UNITED STATES PATENT AND TRADEMARK OFFICE

APPLICATION NO.	FILING DATE	FIRST NAMED INVENTOR	ATTORNEY DOCKET NO.	CONFIRMATION NO.
10/030,595	01/08/2002	Robert W. Tritchler	GRC 19.329 (100671-00050)	6456
26304	7590	05/03/2005	EXAMINER	
KATTEN MUCHIN ZAVIS ROSENMAN 575 MADISON AVENUE NEW YORK, NY 10022-2585			DUNWOODY, AARON M	
			ART UNIT	PAPER NUMBER
			3679	
DATE MAILED: 05/03/2005

Office Action Summary

DETAILED ACTION

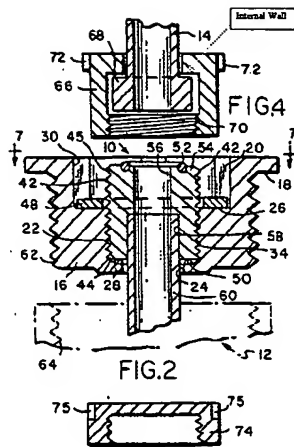
In regards to claim 21, Bedeker discloses the housing including an internal wall (see Figure 2 below), offset from one end of the housing, with an opening therethrough.
